UNITED STATES PATENT AND TRADEMARK OFFICE

APPLICATION NO.	FILING DATE	FIRST NAMED INVENTOR	ATTORNEY DOCKET NO.	CONFIRMATION NO.
09/676,722	09/28/2000	Donald L. Wilson	12548US02	2793

Office Action Summary

DETAILED ACTION

**FIG. 1**

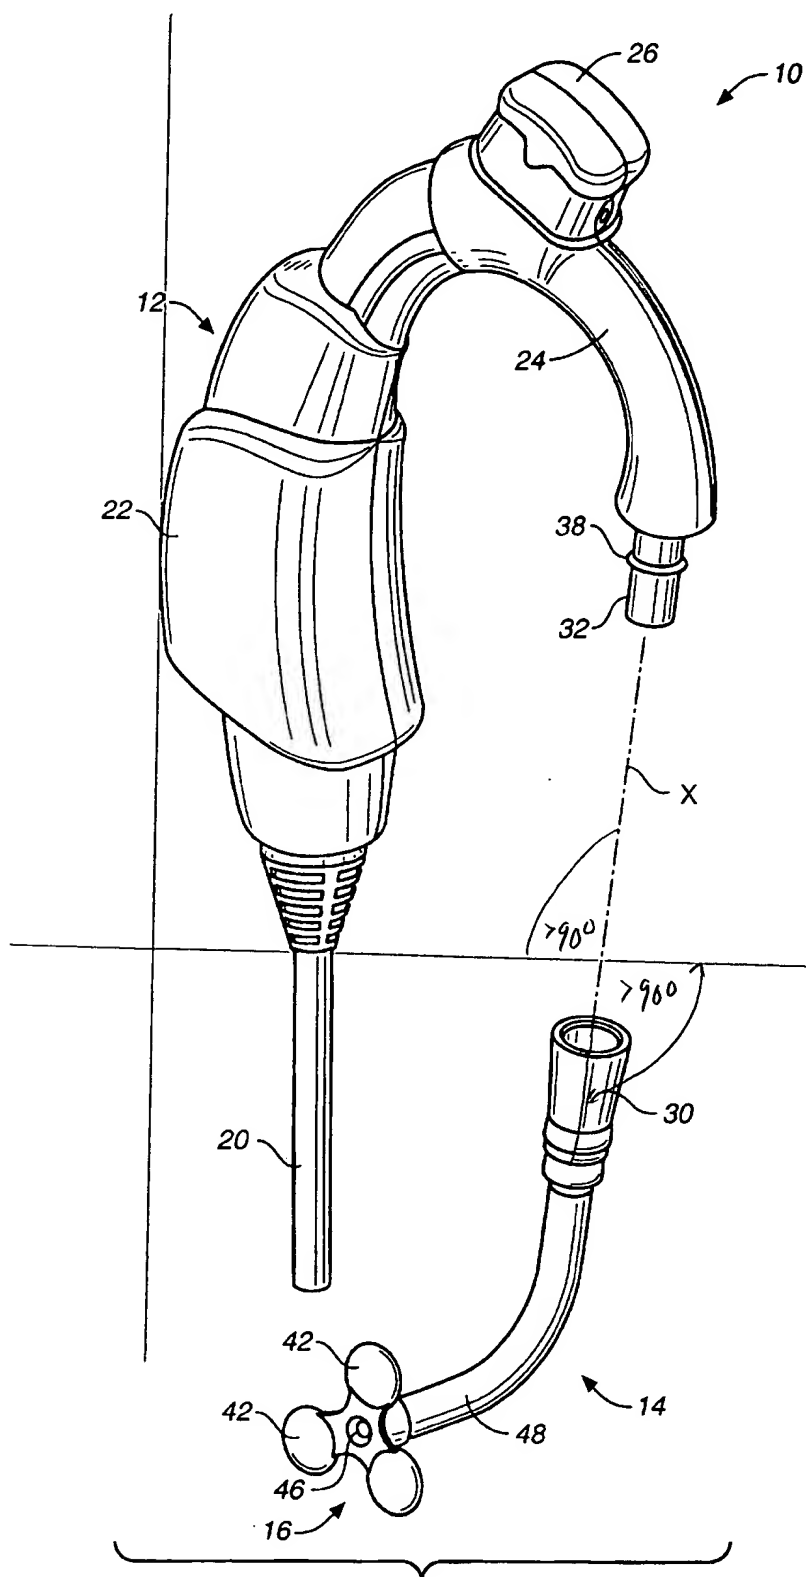
Regarding **claim 1**, Taenzer discloses a sound delivery tube system. Taenzer's disclosure comprises a sound delivery system body (12), which reads on a housing; a microphone (26), which reads on a receiver; a sound delivery tube (14) with an eartip, (16), which reads on the flexible eartip and a rigid tube nipple, and a flexible channel, and inherently discloses a flexible channel as evident by the fact of a sound transmission tube, therein (figures 1 and 2, col. 2, lines 51-61, col. 3, lines 1-22, and col. 4, lines 20-42). In figures 1 and 2, Taenzer the sound delivery body (housing) discloses the housing and tube for an obtuse angle, and thus hangs vertical to the ear of the user (see the attached drawings).

Regarding **claim 16**, Taenzer discloses everything claimed as applied above (see claim 15). In figures 1 and 2, Taenzer the sound delivery body (housing) discloses the housing and tube for an obtuse angle, and thus hangs vertical to the ear of the user (see the attached drawings)

and a rigid tube nipple composed of a hose (30) providing a sound conduit (flexible channel), wherein is inherent the tube begins inside of the housing and extend outside (see figures 1 and 2) and as well Schiess provides an obtuse angle between the housing and the axis of the tube (please see the attached drawings). However, Schiess fails to specifically disclose the eartip as being flexible. The use of a flexible eartip was well known. Thus, it would be obvious to one of the ordinary skill in the art to modify the eartip of Schiess by providing a flexible eartip, such as foam for the purpose of providing comfort to the user ears.
